**PROJECT: WASHINGTON ST., VISTA DR. TO THIRD AVE.
IMPROVEMENT PROJECT # ST2014-04**

ADDENDUM NO. 1
To the Contract Provisions for
CITY OF FERNDALE, WASHINGTON

Washington St., Vista Dr. to Third Ave. Improvement Project
ST2014-04

WASHINGTON STREET
VISTA DR. TO THIRD AVENUE PROJECT
TESC AND DEMO PLAN STA 6+00 - 12+00

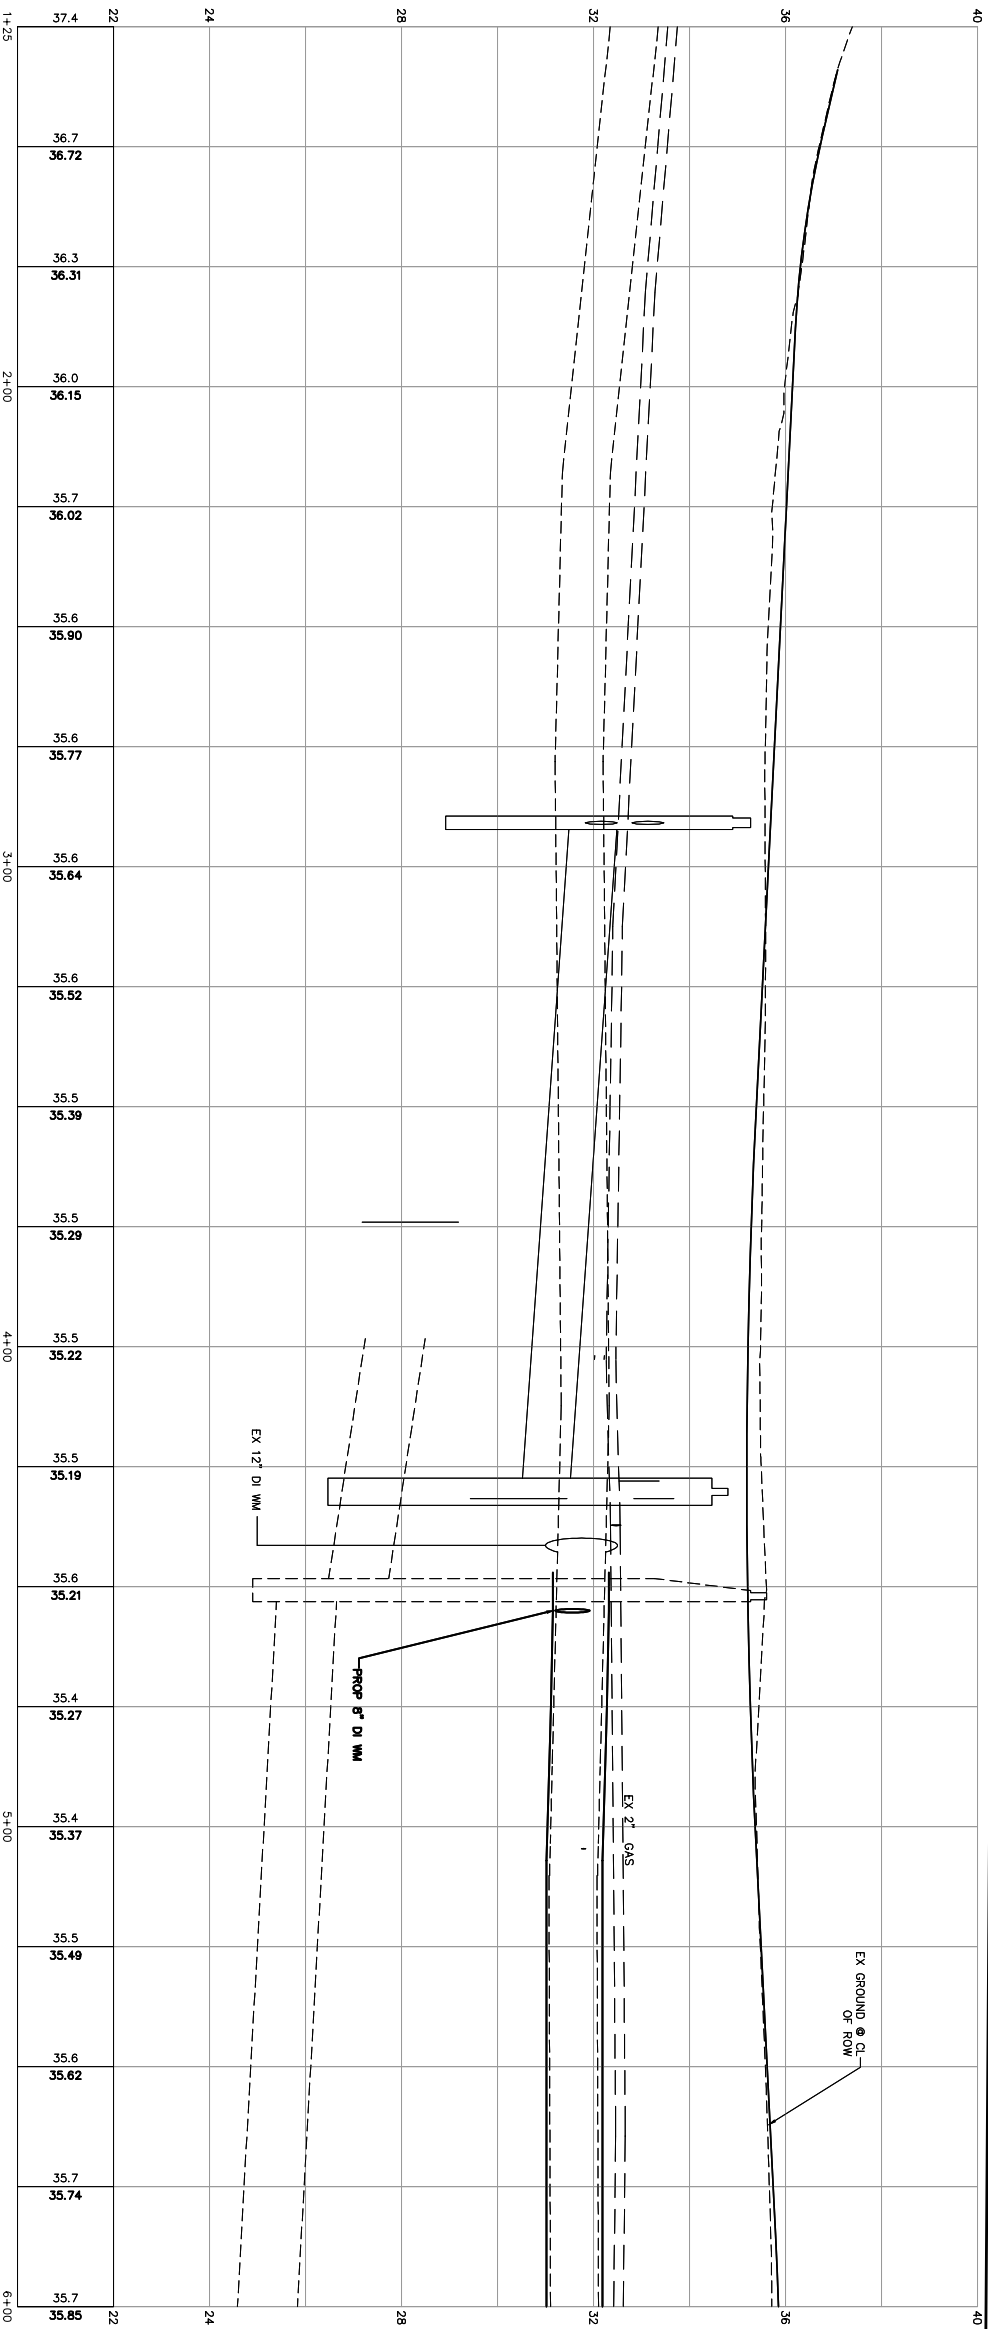
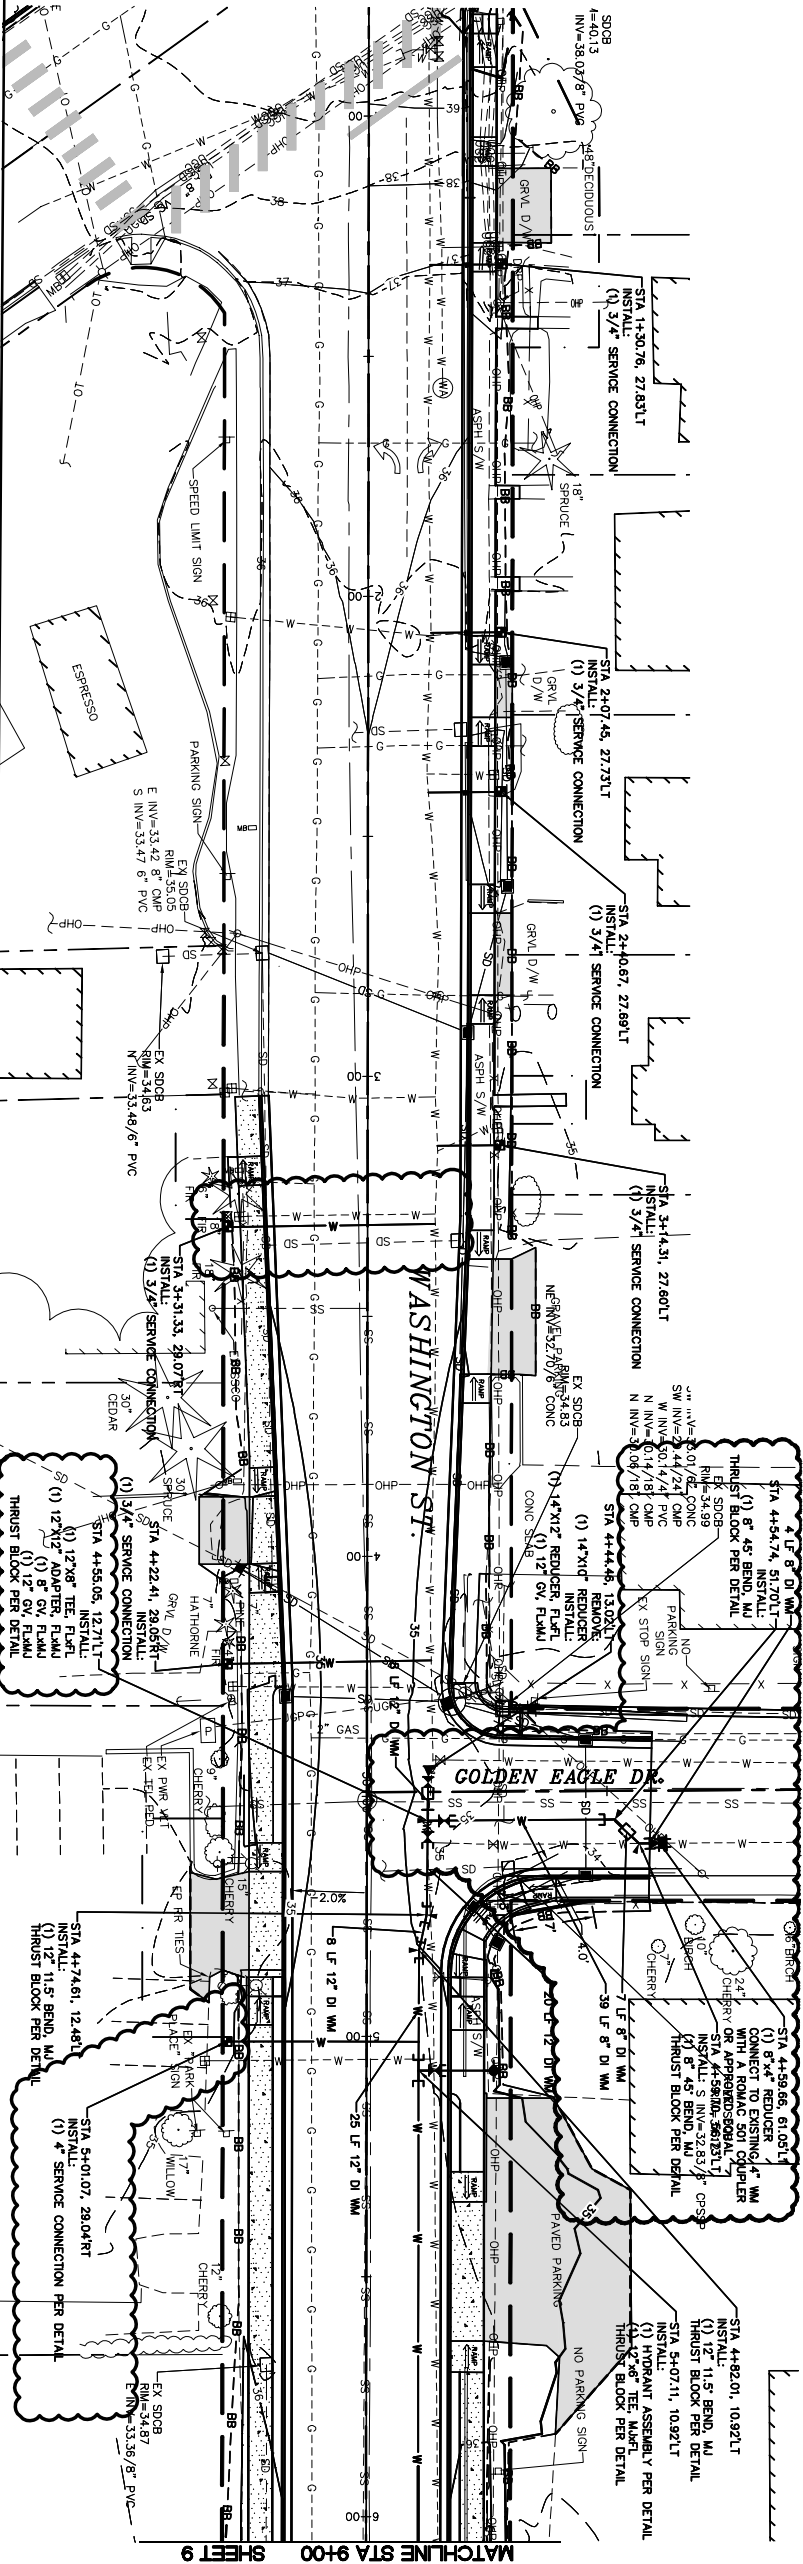
- Plan Sheet 5. The demo notes between approximately 7+00 RT to 8+00 RT are revised.
- Plan Sheet 8. Pedestrian curb between approximately STA 9+28 LT to 9+43 LT has been removed.

WASHINGTON STREET
VISTA DR. TO THIRD AVENUE PROJECT
WATER PLAN AND PROFILE STA 1+25 - 6+00

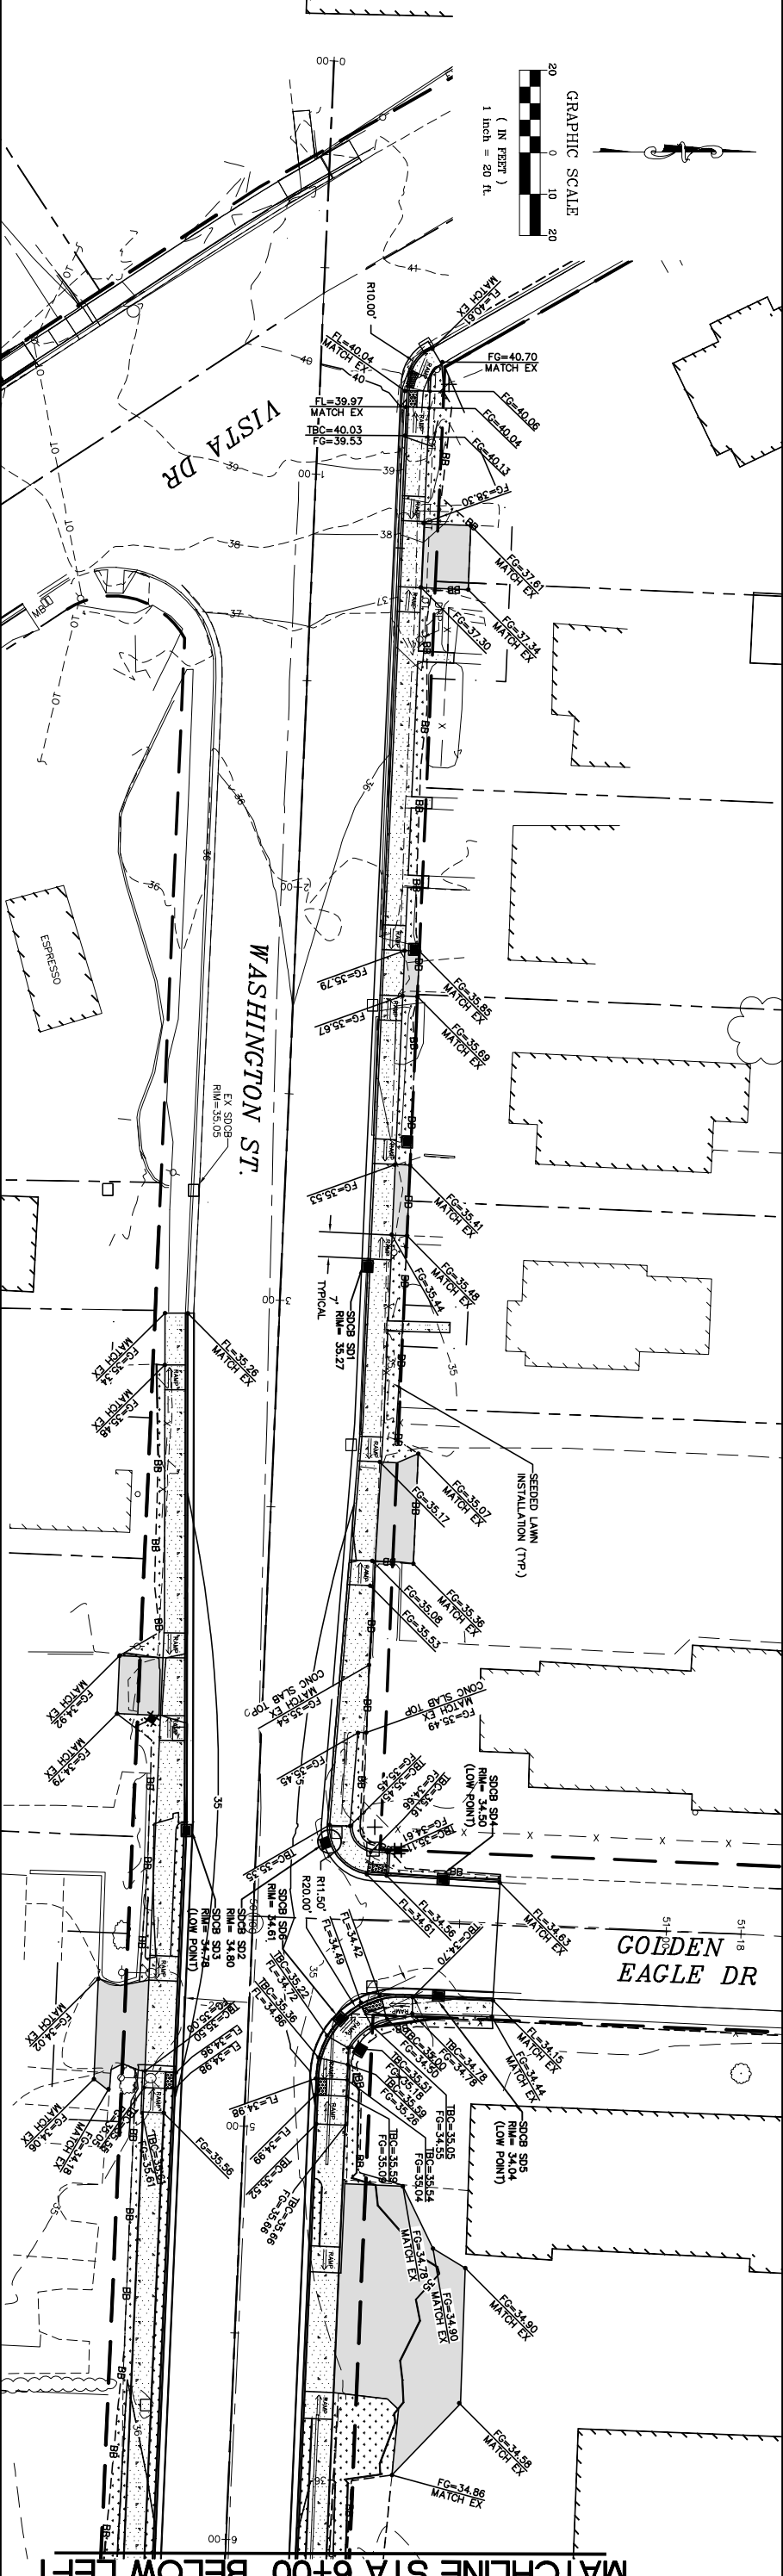
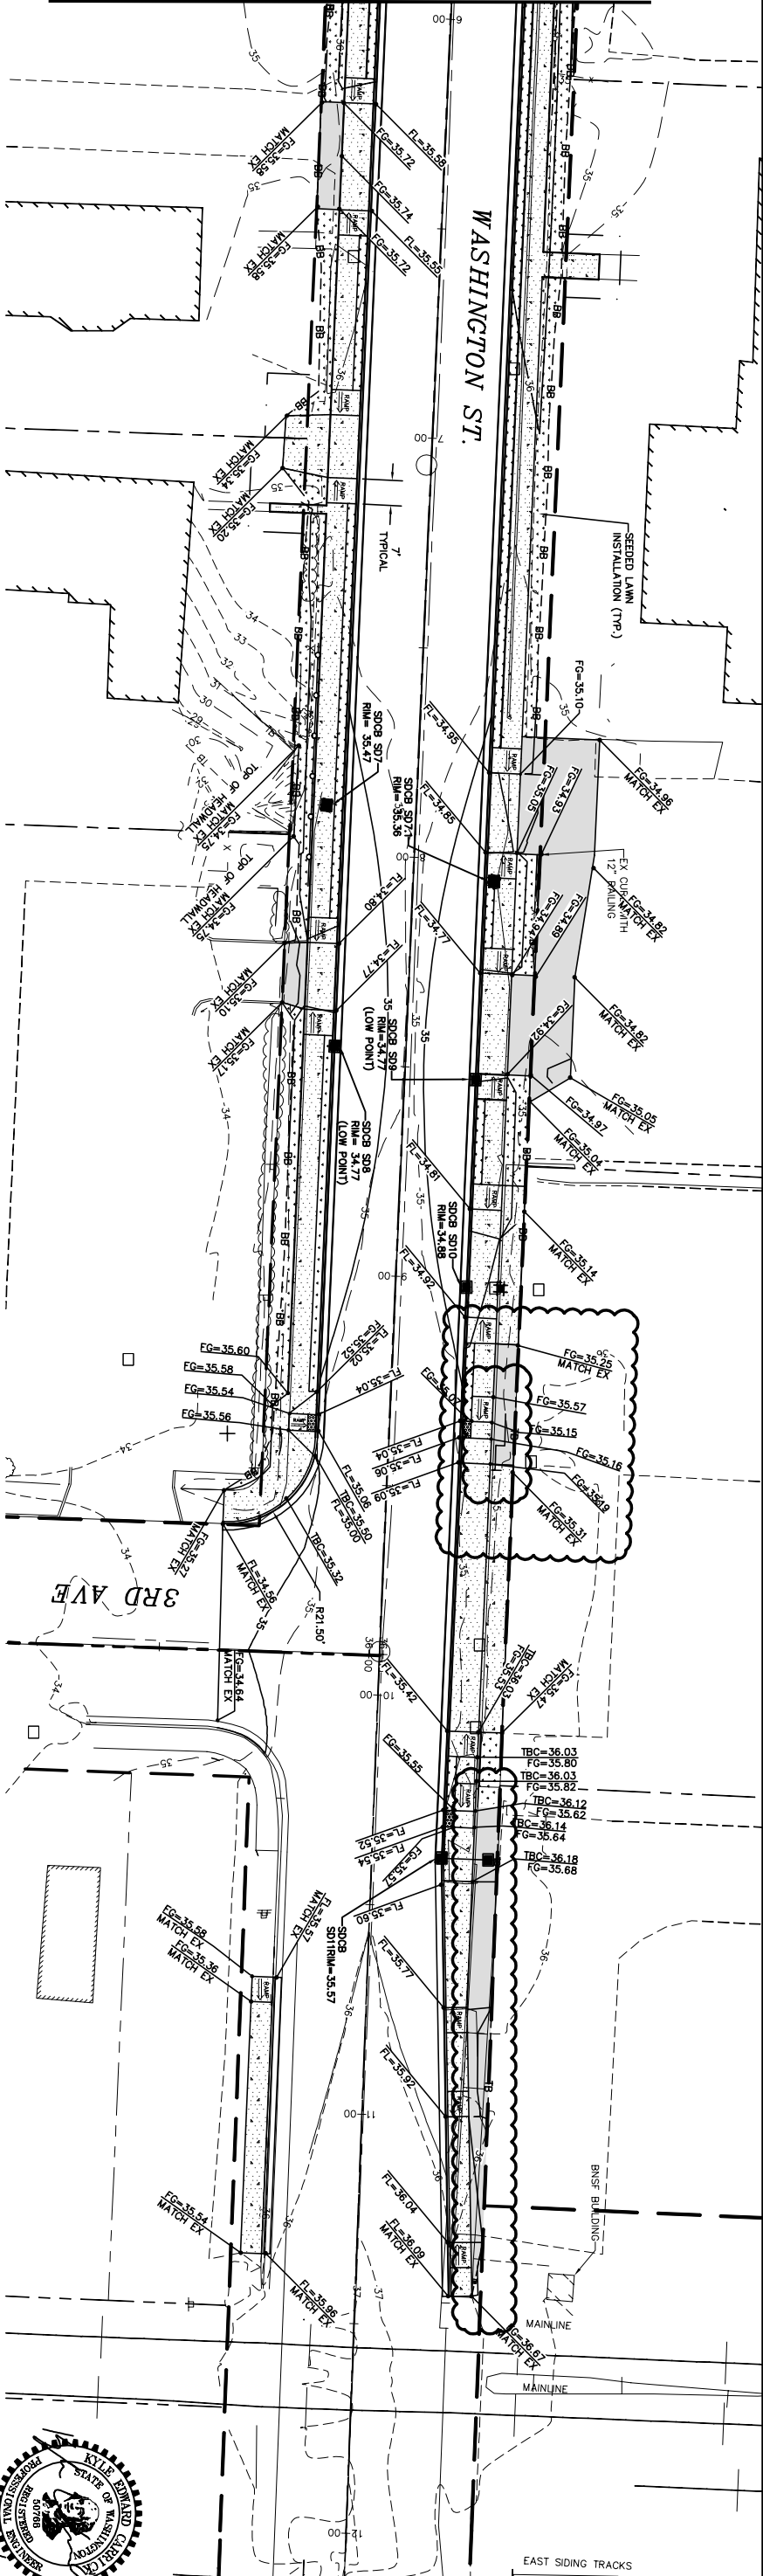
- Plan Sheet 9.
 - Approximately STA 3+31 RT. ¾” service line from existing watermain to the proposed meter is added.
 - Approximately STA 4+55 LT. 4” watermain and fitting changed to 8” watermain and fitting.
 - Approximately STA 5+01 RT. ¾” service changed to 4” service.
- Plan Sheet 10. Approximately STA 7+62, LT. ¾” service changed to 2” service.
- Plan Sheet 13.
 - Grade call outs for the removed pedestrian curb between approximately STA 9+28 LT to 9+43 LT have been revised.
 - Crushed Surfacing Top Course for driveways between approximately 9+15 LT to 11+00 LT have been revised to asphalt.
- Plan Sheet 14. The “Proposed Concrete Driveway Section” detail has been revised.

CITY OF FERNDALE 4" METER INSTALLATION

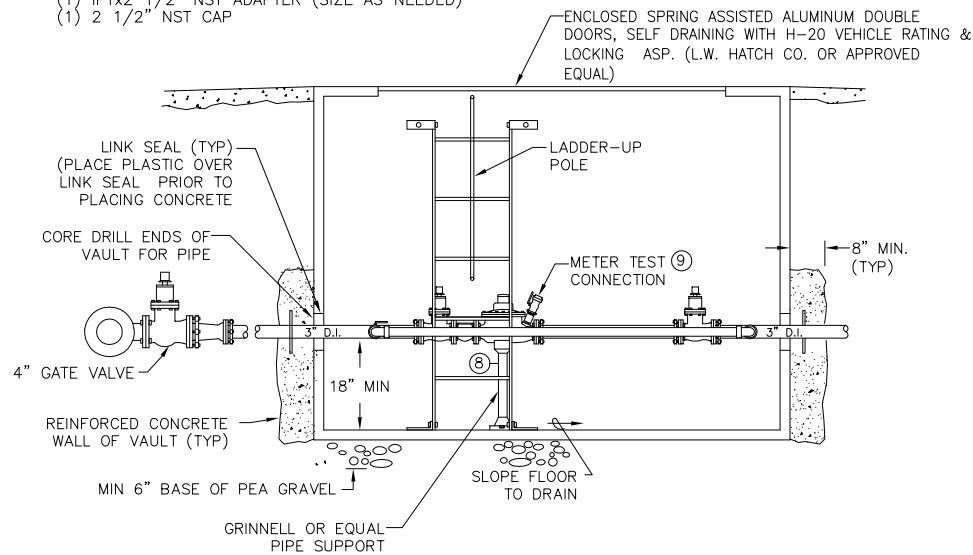
The attached 4 In. Diam. Service Connection Detail is added to the Contract Documents.
